**ADDENDUM NO. ONE (1)**

**REHABILITATE AIRFIELD SIGNAGE AND LIGHTING**

**ROANOKE-BLACKSBURG REGIONAL AIRPORT  
ROANOKE, VIRGINIA**

**JUNE 3, 2020**

**PULLCAN DETAIL**

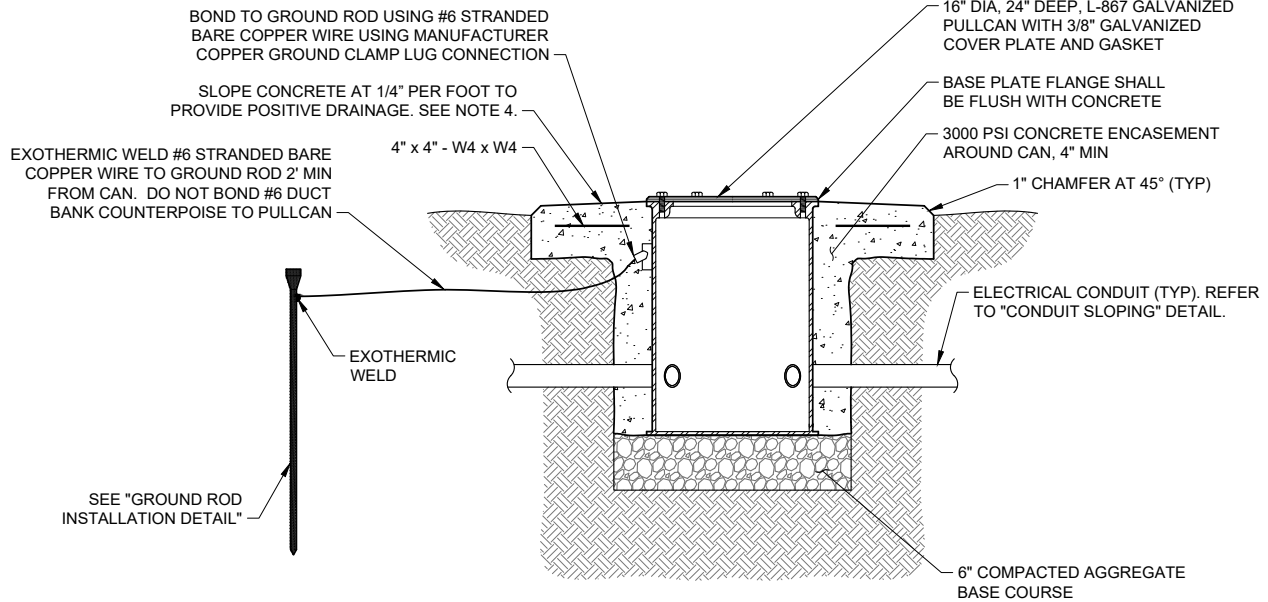
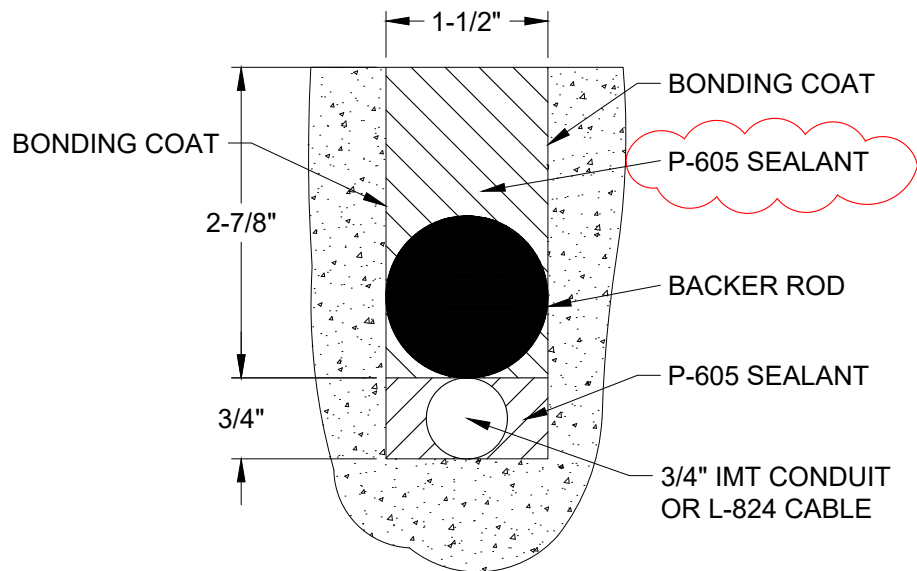
- 15. REPLACE** the “PULLCAN DETAIL” with the attached “PULLCAN DETAIL” shown in the attached Exhibit 47-1 of Addendum No. One (1)

21. QUESTION: Drawing 47 PULLCAN DETAIL shows a 2” PVC pipe (min. 1% slope) to sump (see note 2). There are no details showing a sump and the drainpipe is not shown on the drawings, except for the one noted previously. Note 2 addresses bonding direct buried bare wire, not sumps.

ANSWER: Reference is directed to Exhibit 47-1 of Addendum No. One (1).

1. PULLCANS, CONCRETE, CONDUIT, W4 x W4, AGGREGATE, GROUND ROD, COUNTERPOISE, EXCAVATION, AND BACKFILL ARE INCIDENTAL TO THE COST OF THE PULLCAN PLAZA.
2. ALL DIRECT BURIED BARE WIRE CONNECTIONS SHALL BE EXOTHERMIC WELDS ONLY. LUG CONNECTIONS SHALL BE USED FOR CONCRETE ENCASED APPLICATIONS.
3. CONCRETE SURFACE SHALL RECEIVE A BROOM FINISH.
4. CONTRACTOR SHALL LABEL EACH CAN LID FOR CIRCUIT IDENTIFICATION. SEE "PULLCAN LID LABEL DETAIL". SPARE PULLCANS SHALL NOT BE LABELED.

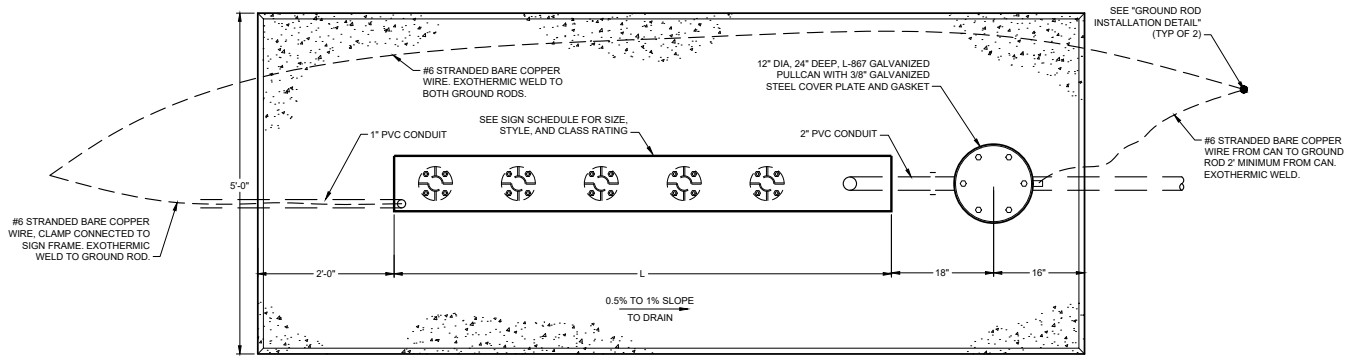
- 18. REPLACE** the “SAW KERF WIREWAY” detail with the attached “SAW KERF WIREWAY” detail shown in the attached Exhibit 51-1 of Addendum No. One (1).

31. QUESTION: Drawing 51 EXISTING SHALLOW CAN IN-PAVEMENT LIGHT has notes that state “New L-864 cable installed in sawkerf with backer rod and sealer or existing ¾” IMC conduit between shallow cans” and note 5 states “Removal and reinstallation of backer rod and sealant shall be considered incidental to the installation of the new cable (NO SEPARATE PAY ITEM)”. Bid item 27 - NO. 10 AWG, 600V, L-824, TYPE C CABLE INSTALLED IN TRENCH, DUCT BANK OR CONDUIT -14,000 LF does not address “installed in sawkerf”. A separate bid item is needed: NO 10 AWG, 600V, L824 TYPE C INSTALLED IN EXISTING SAWKERF– REPLACE BACKER ROD AND SEALANT - XX LF.

1. CONTRACTOR SHALL VERIFY EXISTING FIELD CONDITIONS PRIOR TO CONSTRUCTION.
2. REMOVAL AND REPLACEMENT OF BACKER ROD AND SEALANT IN EXISTING SAW KERFS SHALL BE PAID PER LINEAR FOOT UNDER P-605 "JOINT SEALING FILLER".

**LED AIRFIELD GUIDANCE SIGN DETAIL  
(OPTIONAL PRECAST PAD)**

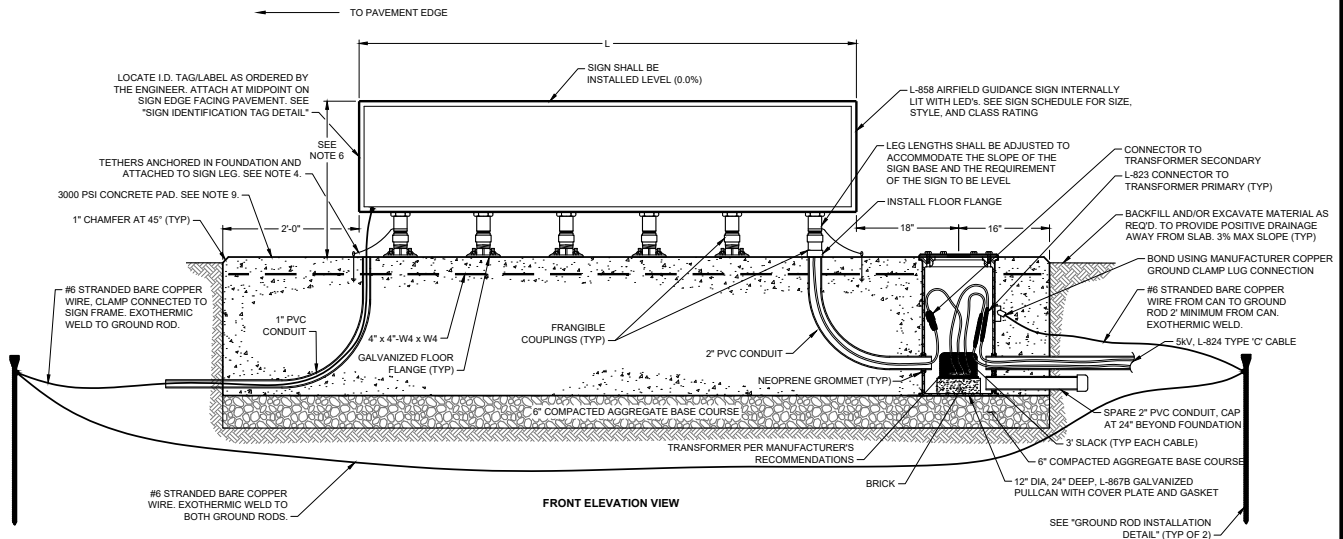
20. **ADD** Sheet 52A.
21. **ADD** the “LED AIRFIELD GUIDANCE SIGN DETAIL (OPTIONAL PRECAST PAD)” as shown in the attached Exhibit 52A-1 of Addendum No. One (1).

1. PROVIDE A L-823 DISCONNECT PLUG & RECEPTACLE IN THE FRANGIBLE COUPLING OF THE POWER LEG AS REQUIRED.
2. ALL CONDUIT UNDER THE CONCRETE PAD IS INCIDENTAL TO THE COST OF THE AIRFIELD GUIDANCE SIGN.

7. CONTRACTOR TO COORDINATE DEPTH OF PAD WITH MANUFACTURER'S RECOMMENDED ANCHOR BOLTS.
8. PROVIDE EXTERNAL POWER DISCONNECT (ON/OFF) SWITCH TO ISOLATE THE SIGN FROM THE CIRCUIT FOR MAINTENANCE.

9. CONCRETE SURFACE SHALL RECEIVE A BROOM FINISH.
10. THE USE OF PRECAST PADS IS AT THE CONTRACTOR'S OPTION; NO ADDITIONAL PAYMENT WILL BE MADE FOR THE USE OF PRECAST PADS.

**SOLAR OBSTRUCTION LIGHT DETAIL**

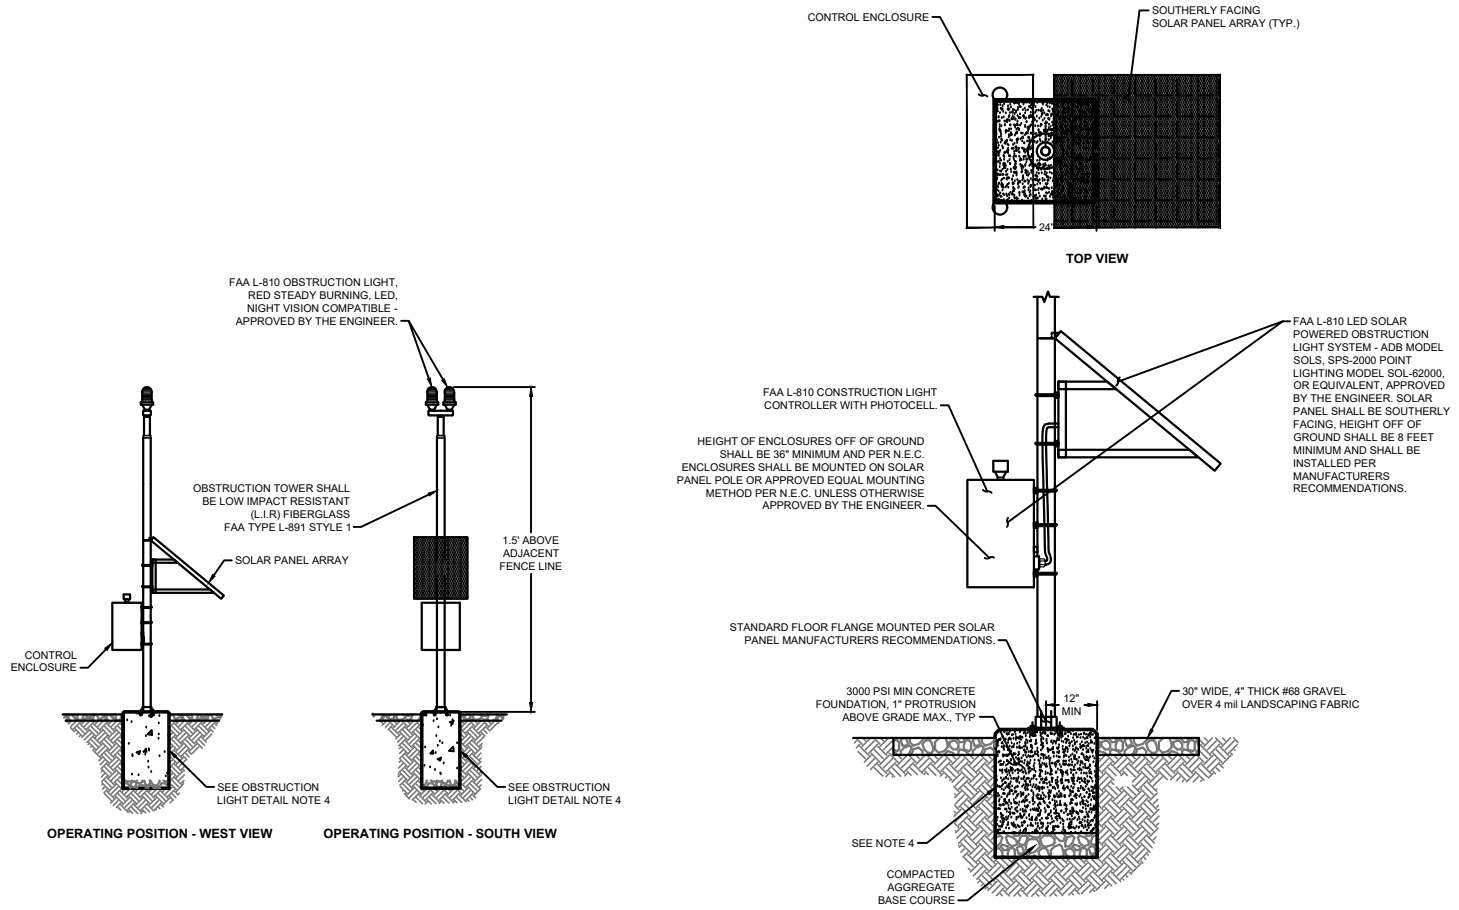
- 27. ADD** the “SOLAR OBSTRUCTION LIGHT DETAIL “as shown in the attached Exhibit 59-1 of Addendum No. One (1).

19. QUESTION: Drawing 22 shows a solar powered obstruction light that is noted “Remove existing fixture and install a new LED obstruction light”. Is this included in Bid Item 36-REPLACE OBSTRUCTION LIGHT FIXTURE (LED) IN PLACE? Please provide a specification for the solar obstruction light and power supply.

ANSWER: Reference is directed to Exhibit 59-1 of Addendum No. One (1).

3. ALL WORK SHOWN IS INCIDENTAL TO THE UNIT PRICE PER EACH FOR "INSTALL SOLAR AIRPORT OBSTRUCTION LIGHT (LED)".
4. OBSTRUCTION LIGHT TOWER FOUNDATION DETAIL SHOWN HERE IS FOR GENERAL INFORMATION PURPOSES ONLY. TOWER FOUNDATION SHALL BE DESIGNED TO WITHSTAND A LOADING PER POLE MANUFACTURERS RECOMMENDATIONS. THE INFORMATION SHOWN IS REPRESENTATIVE OF TYPICAL OBSTRUCTION LIGHT TOWER FOUNDATION.

5. OBSTRUCTION TOWER SHALL BE LOW IMPACT RESISTANT (L.I.R) FIBERGLASS AND IN ACCORDANCE WITH FAA TYPE L-891 STYLE 1.
6. ALL EQUIPMENT SHALL BE LISTED IN THE LATEST EDITION OF APPENDIX I OF FAA ADVISORY CIRCULAR 150/5345-53D, AIRPORT LIGHTING EQUIPMENT CERTIFICATION PROGRAM. SOLAR POWER SYSTEM SHALL MEET THE REQUIREMENTS OF FAA ENGINEERING BRIEFS 67 AND 76. MANUFACTURERS OF LIGHTS AND OF SOLAR POWER SYSTEM SHALL PROVIDE CERTIFICATION EACH IS COMPATIBLE AND THAT SYSTEM IS ABLE TO POWER BOTH LIGHTS FROM "DUSK TO DAWN" ON SHORTEST DAY OF THE YEAR.
